CERTIFICATE OF APPROPRIATENESS

Property: 2236 Stanmore Drive, Lot 24, Block 43, River Oaks Section 1 Subdivision. The property includes a 4,299 square foot, two-story brick veneer single-family residence situated on an 8,093 square foot (65' x 125') interior lot.

Proposal: Alteration – Roof and siding

Recommendation: Denial - does not satisfy criteria 1,3,4, and 9

SOUTH ELEVATION – FRONT FACING STANMORE DRIVE

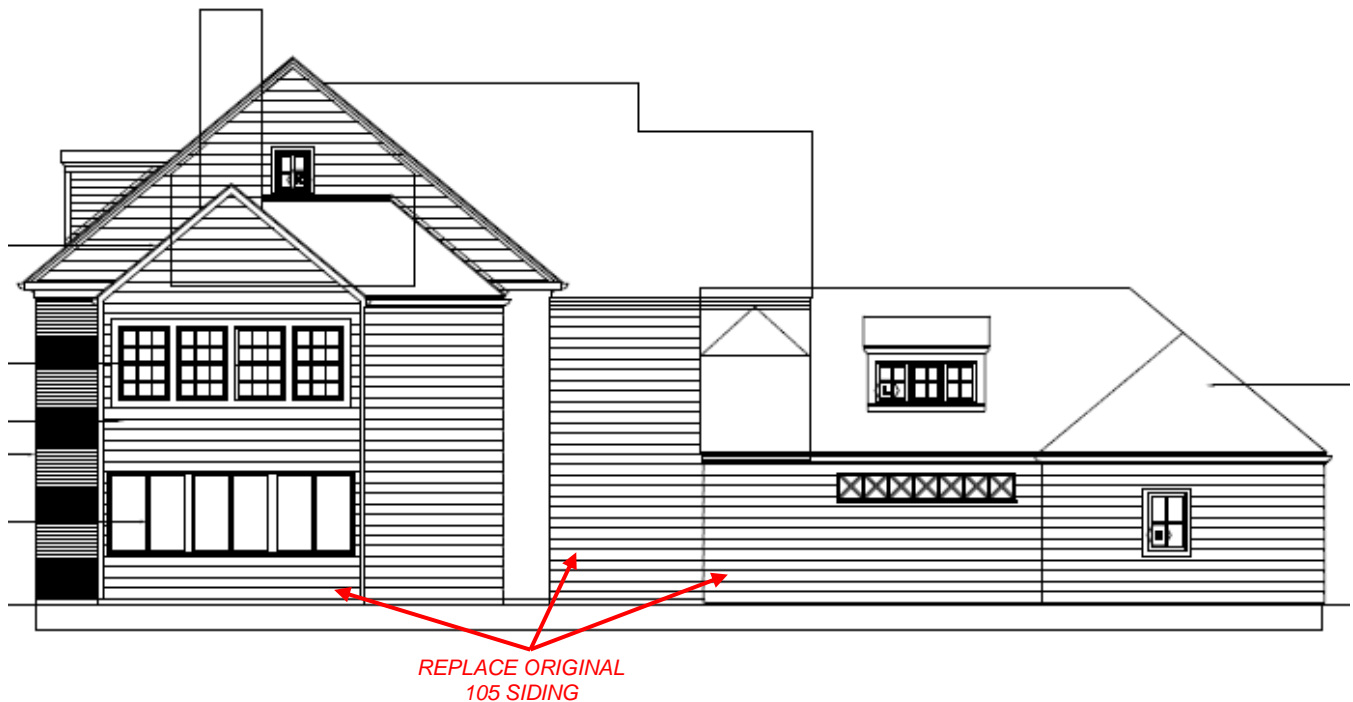
<i>The original hip roof was integral to the historic character of the Georgian residence and should be retained and preserved. The side gable roof with dormers presents a new dominant feature at the front façade that compromises the original historic character which was dominated by the symmetrical front brick façade.</i> |

<i>The original design was a hip-roof Georgian residence. The replacement of the original hip roof with the new cross gable roof creates a false sense of history by introducing a new architectural element that was never present on the historic structure.</i> |

ROOF PLAN

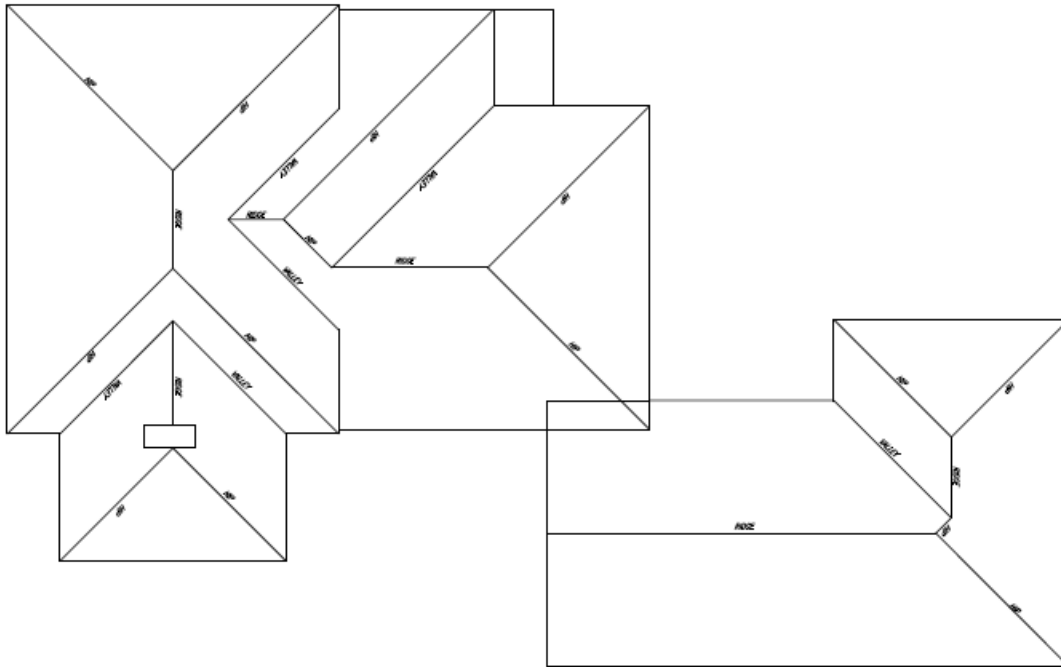
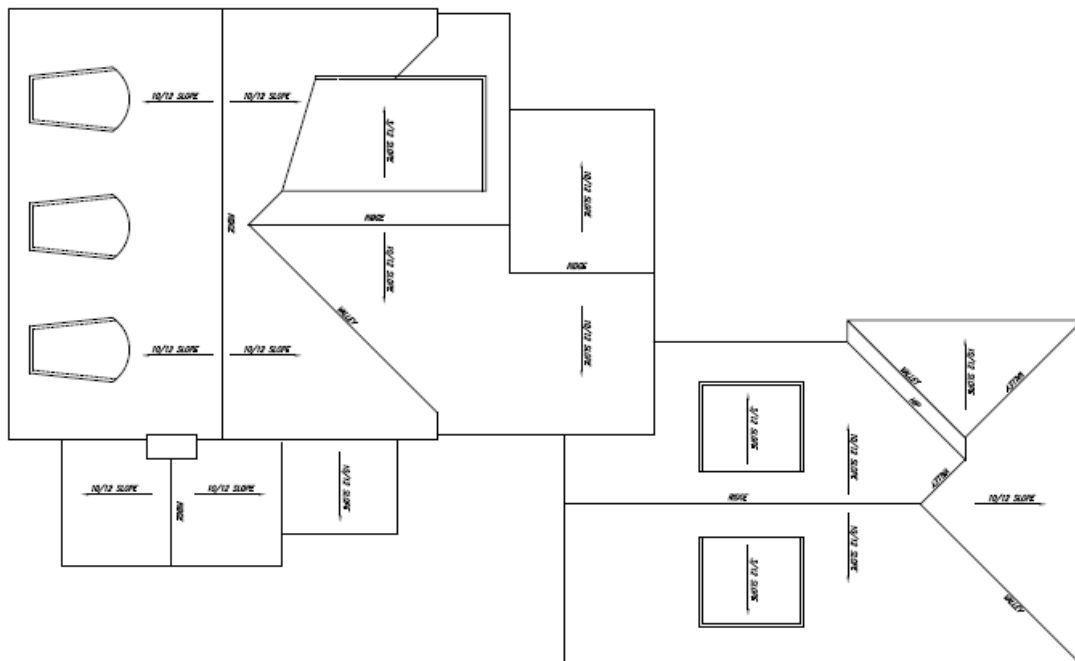
<i>The original hip roof was part of the original design and character of the Georgian residence and should be preserved. The new cross gable roof significantly alters the historic character, replacing an originally more subtle roof configuration with a more complex and dominant roof configuration. The original 105 wood siding at the sides had a visual character that cannot be duplicated with cementitious siding.</i> |

<i>The removal of the original hip roof and 105 wood siding resulted in the loss of significant historic material and compromised the historic character of the residence. The replacement roof and siding materials are not compatible with the size, scale, material and character of the residence.</i> |

**FRONT ELEVATION**

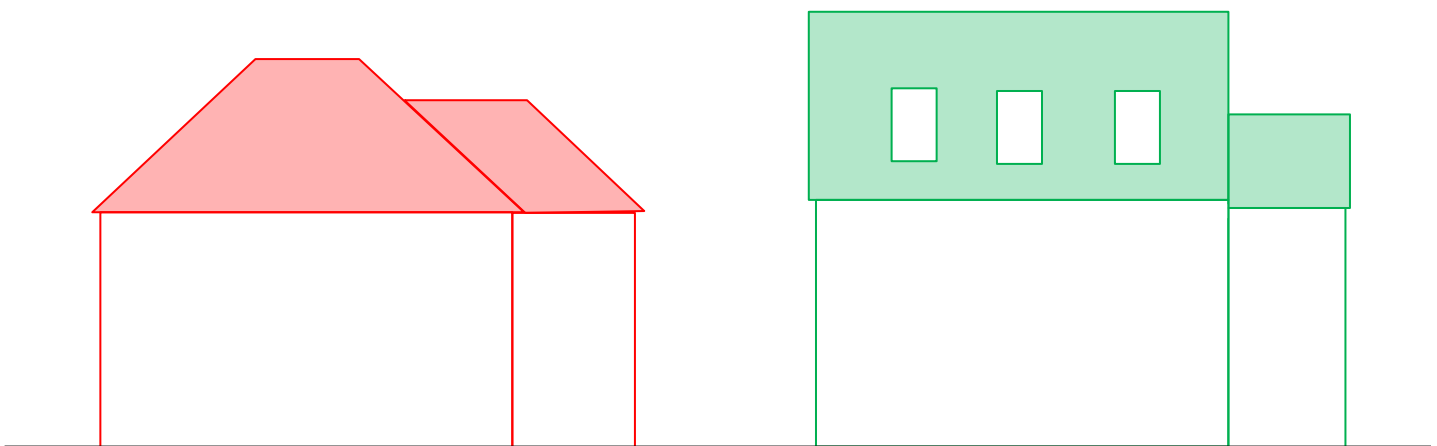
Original side elevation drawings were not available. For purposes of analysis and comparison of the roof alteration, staff created the below original east elevation diagram based on the original front elevation, plan and roof drawings provided by the applicant. The other diagrams were created by tracing elevation drawings provided by the applicant.
